Addendum 01

Modesto Junior College, East Campus
Football Field Press Box & Elevator
435 College Ave., Modesto, CA 95350

Date : October 16, 2026
TETER Project No.: 21-12111

Client Project No.: 26-1957
DSA File No.: 50-C1
DSA Appl. No.: 02-123619

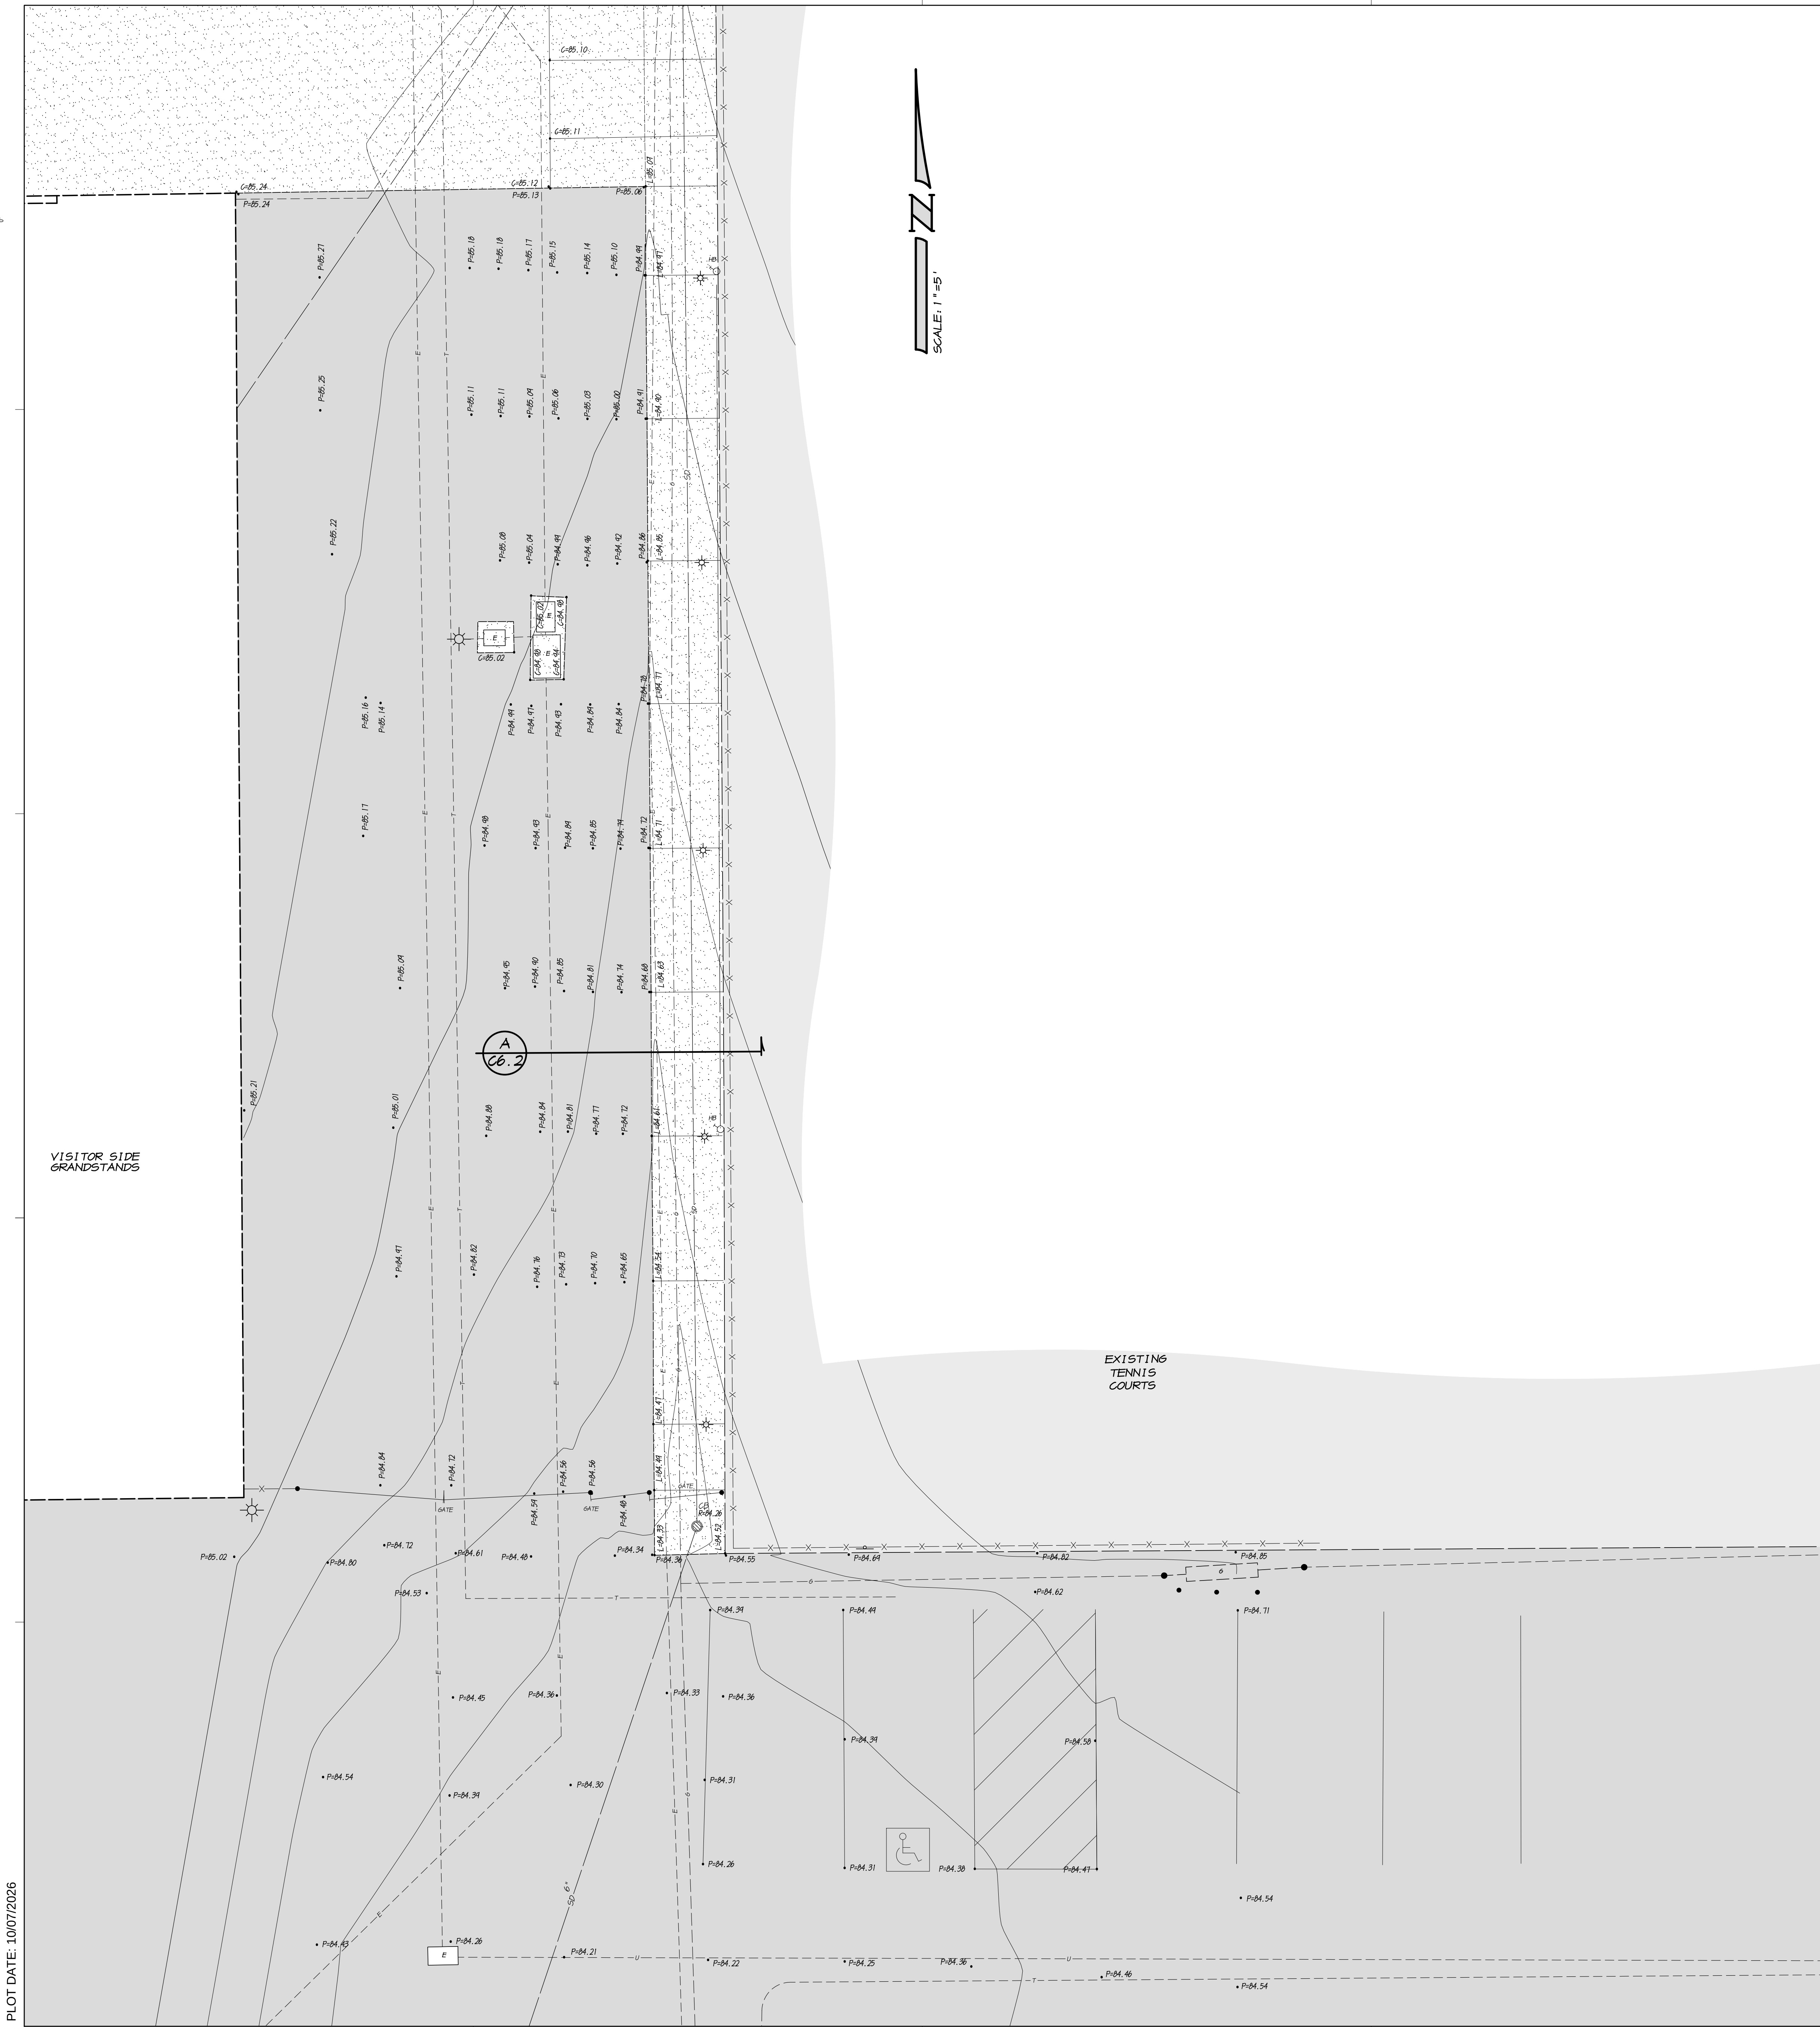
3. **QUESTION:** The FRP strengthening specification defines the system as a contractor delegated design, contradicting the structural drawings which appear to provide a fully engineered FRP layout. Please clarify and advise.

The DSA approved drawings include a complete FRP design from "Structural Technologies." If this design is utilized, no additional design, deferred submittal, and/or DSA approval is required. An alternate FRP design (from a different company) may be utilized, but any changes to the approved design will require a complete review process by DSA at the contractor's expense. If the contractor chooses to utilize the approved design, it is recommended to contact Structural Technologies and include them as a subcontractor as they will need to be retained to install their product.

YCCD - MJC EAST CAMPUS
MODULAR PRESS BOX AND ELEVATOR
435 COLLEGE AVENUE
MODESTO, CA
DRAWING TITLE
DEMOLITION PLAN - VISITOR SIDE CIVIL IMPROVEMENTS

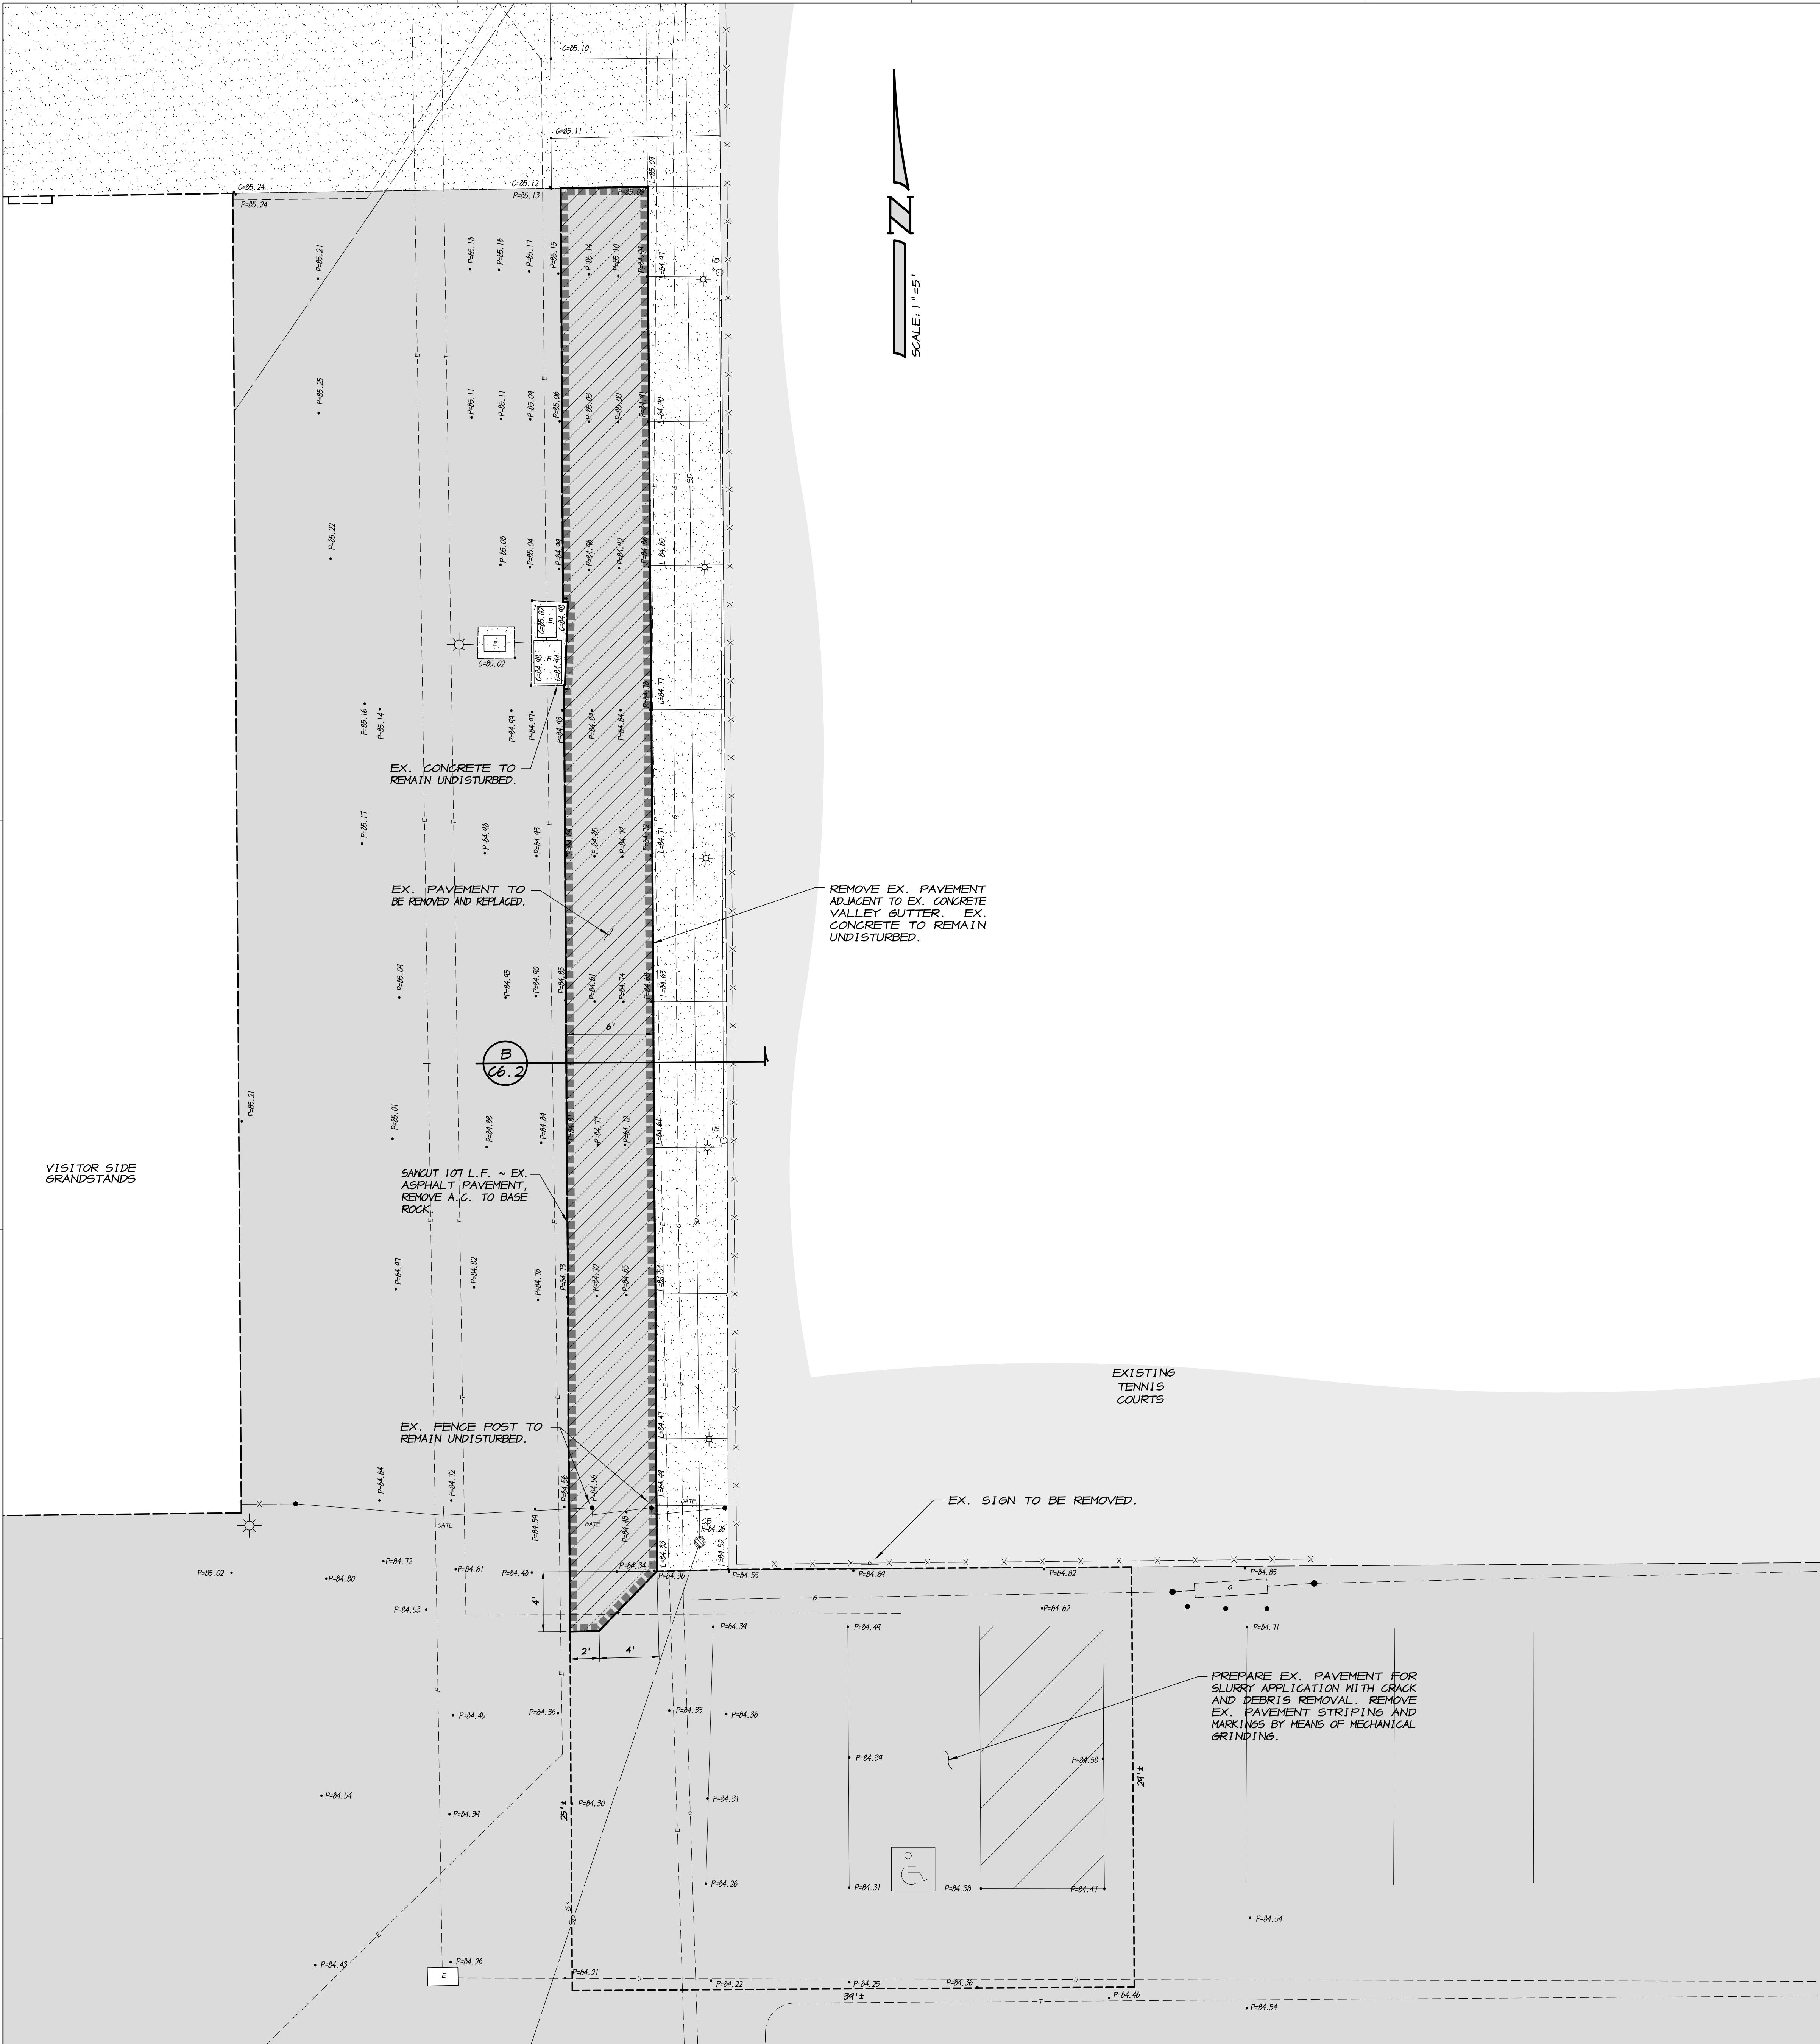
- 1 - 010: PROJECT DRAWINGS, SHEET C6.1 – “DEMOLITION PLAN – VISITOR SIDE - CIVIL IMPROVEMENTS”**, revise as follows:
- A. Add drawing sheet “C6.1 - DEMOLITION PLAN – VISITOR SIDE - CIVIL IMPROVEMENTS” to the PROJECT DRAWINGS (See attachment **AD01-C02_C6.1**)

LAYOUT PLAN - VISITOR SIDE CIVIL IMPROVEMENTS

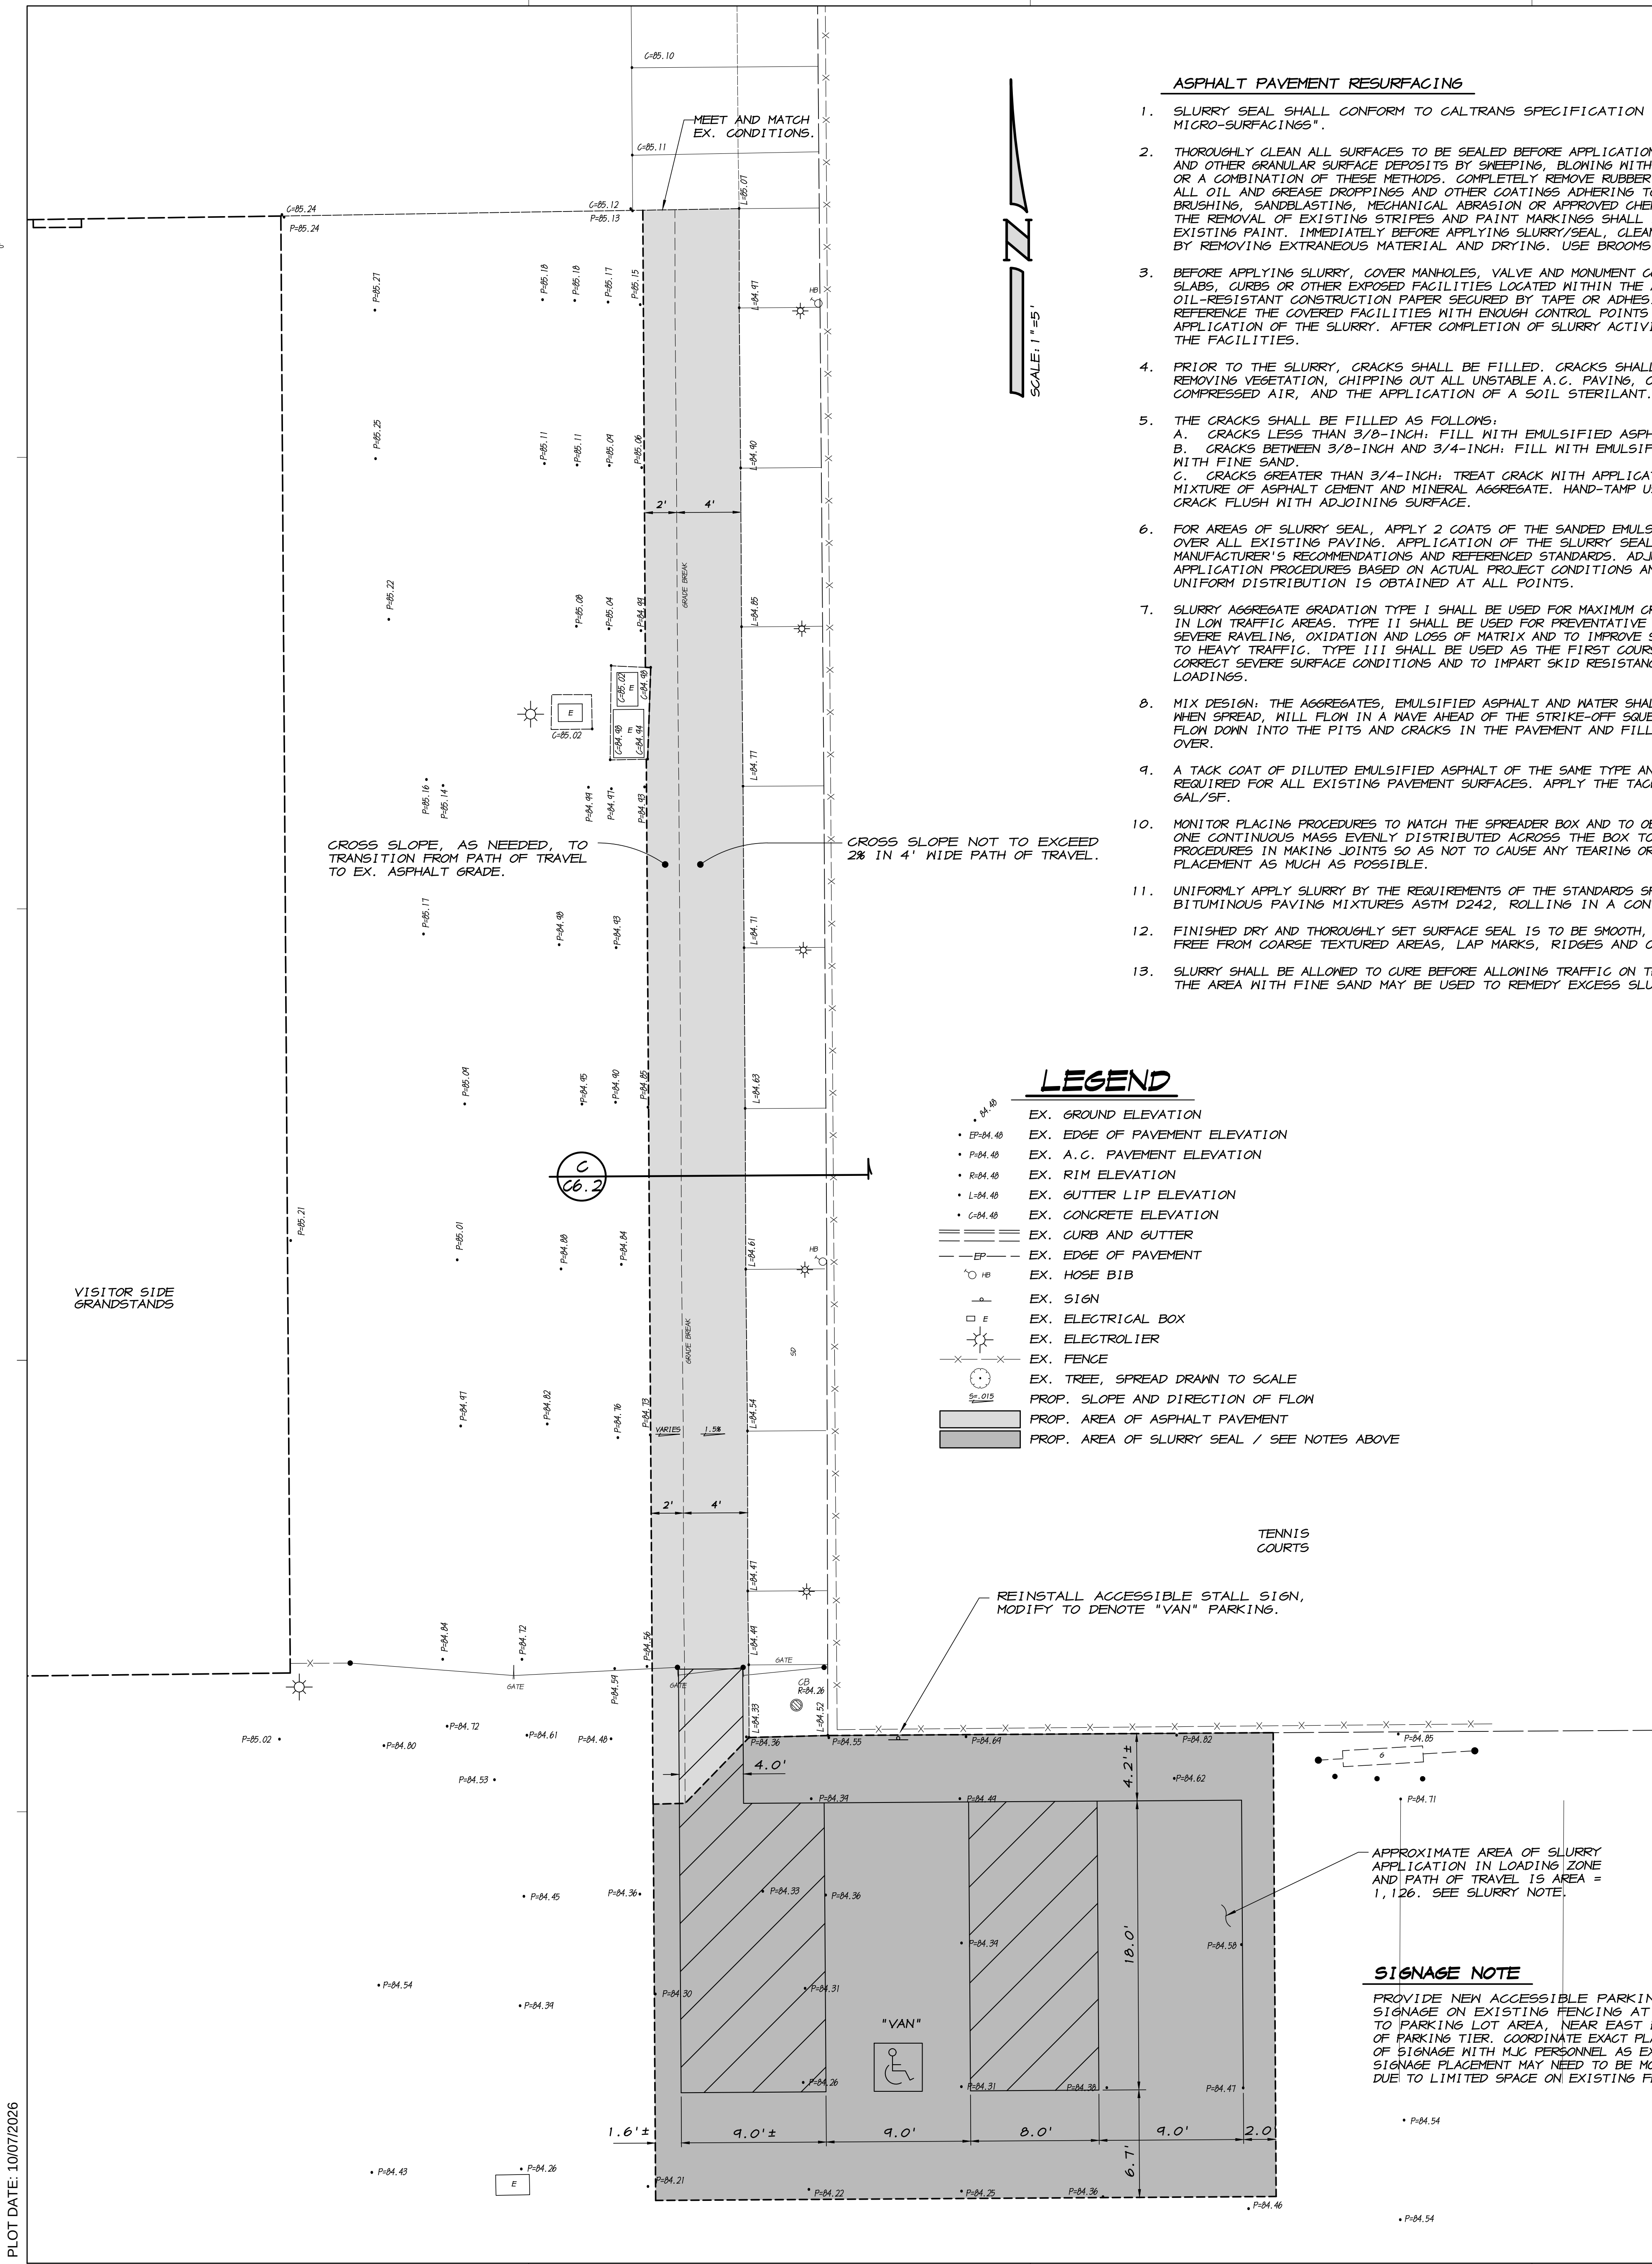
- 1 - 011: PROJECT DRAWINGS, SHEET C6.2 – “LAYOUT PLAN – VISITOR SIDE – CIVIL IMPROVEMENTS”**, revise as follows:
- A. Add drawing sheet “C6.2 - LAYOUT PLAN – VISITOR SIDE - CIVIL IMPROVEMENTS” to the PROJECT DRAWINGS (See attachment **AD01-C03_C6.2**)
